INDIANA DEPARTMENT OF TRANSPORTATION

December 16, 2010 Standards Committee Meeting

REVISION TO THE STANDARD DRAWINGS AND RECURRING PLAN DETAILS

REVISION TO THE STANDARD DRAWINGS AND RECURRING PLAN DETAILS

REVISION TO 601-CWGS-04 CURVED W-BEAM GUARDRAIL SYSTEM

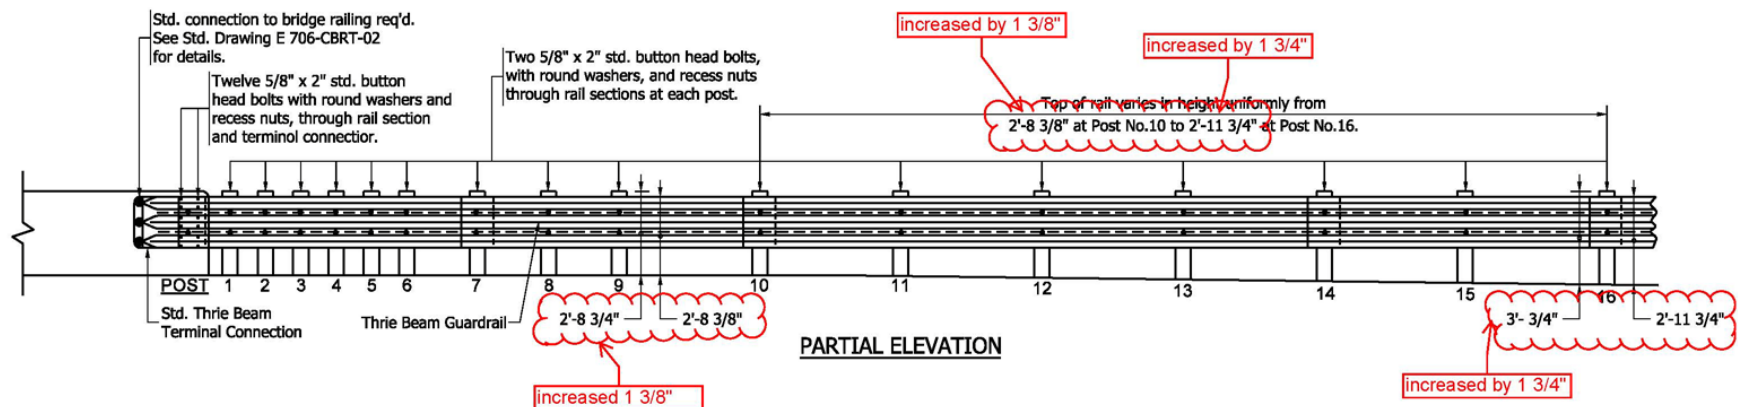
PROPOSED SOLUTION: Revise applicable INDOT Standard Drawings to show the installation height from 27 inches to 27¾ inches to the top of the rail. The proposed change will result into ¾ inch reduced embedment length of the guardrail post which is insignificant and will not impact the strength of the post as the INDOT guardrail posts are 7 feet long compared to 6 feet required for NCHRP 350 TL-3. Also INDOT already has Approved guardrail end treatments that can be used for the 27¾ inches height. The attached drawings are corrected for the changes and the changes are marked on the drawings.

REVISION TO 601-TTGP-02 GUARDRAIL TRANSITION TYPE GP

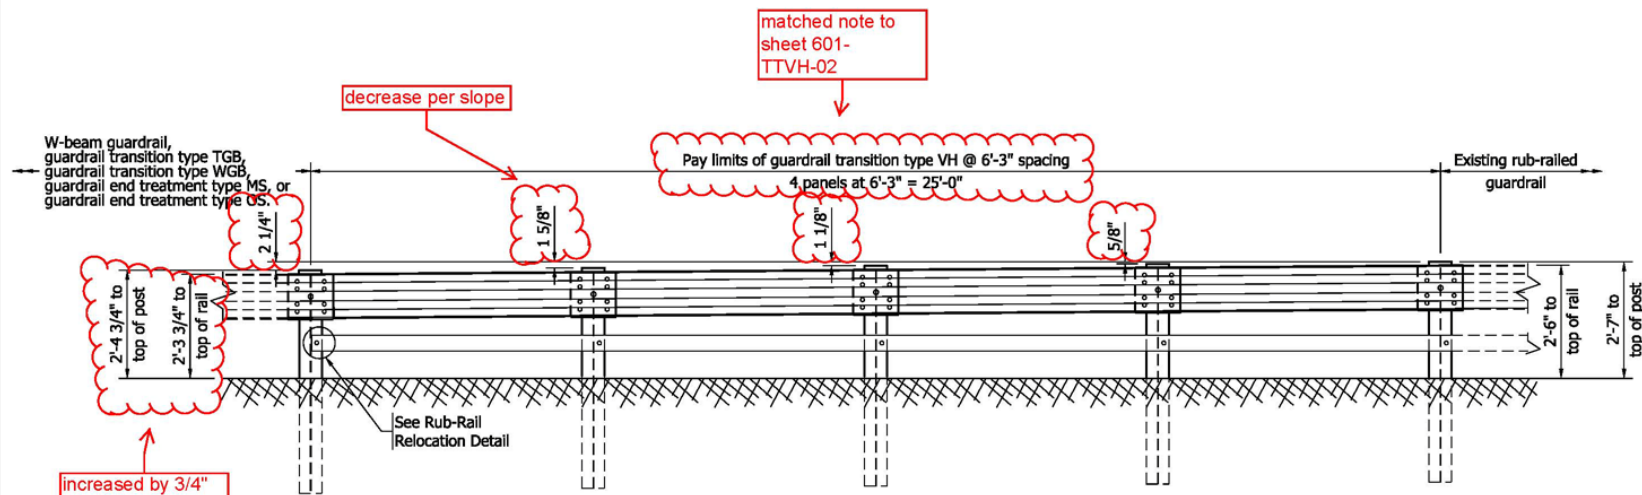
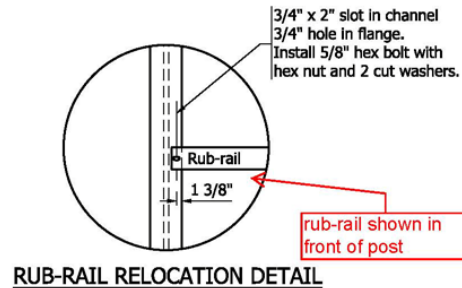
removed notes 1
and 2**NOTES:**

REVISION TO 706-TTBP-05 CONCRETE BRIDGE RAILING TRANSITION, TPS-1

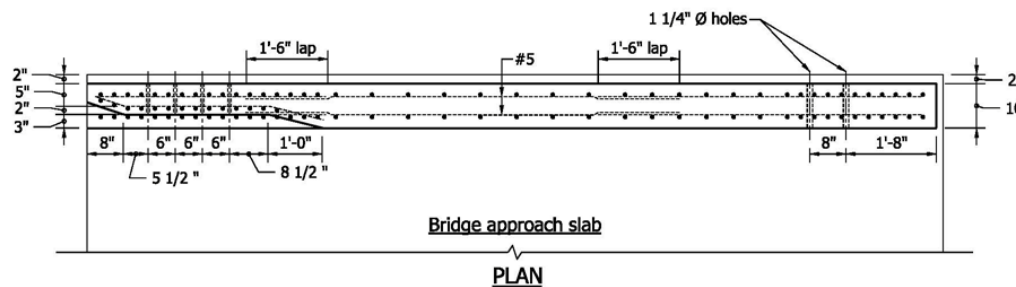
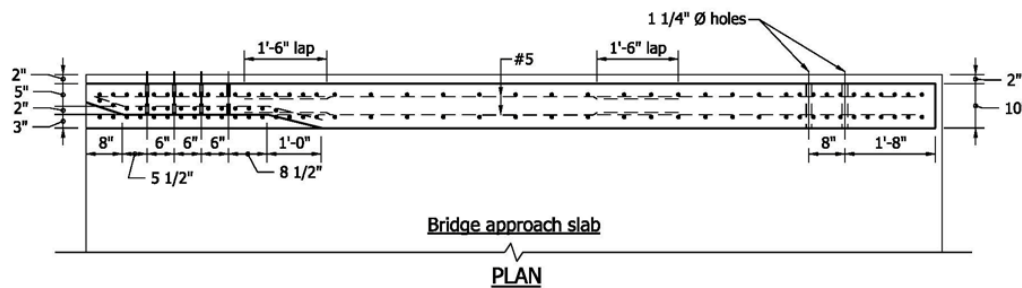
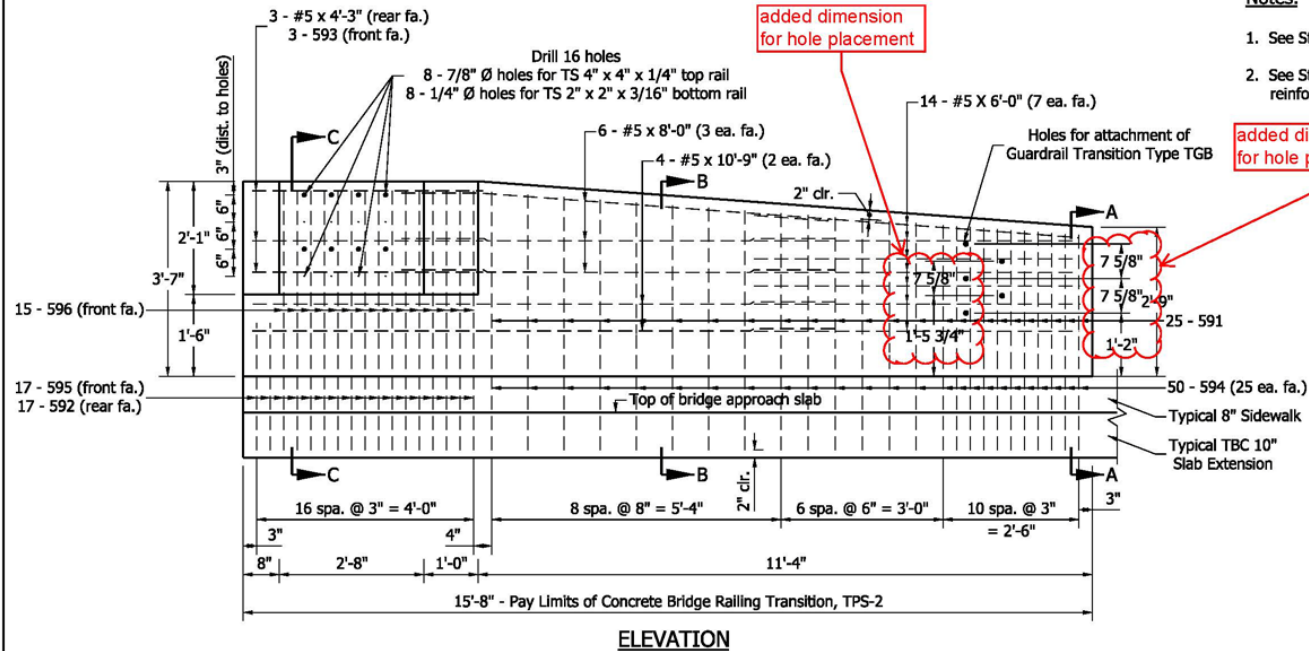
added dimension
for hole placement

REVISION TO RECURRING PLAN DETAILS 706-B-140d BRIDGE RAILING TYPE TS-1 & GUARDRAIL TRANSITION TYPE TGS-1 (PAGE 2 OF 3)

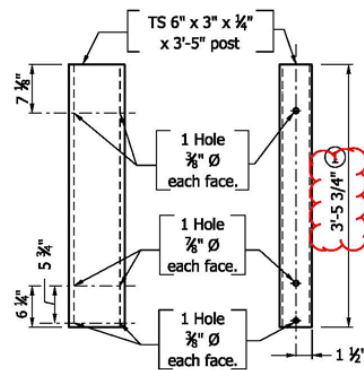
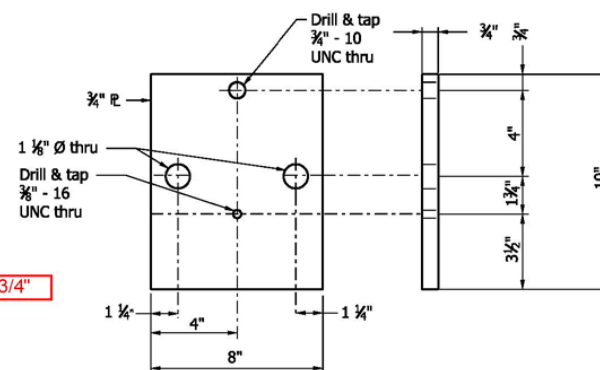
increased by $\frac{3}{4}$ "
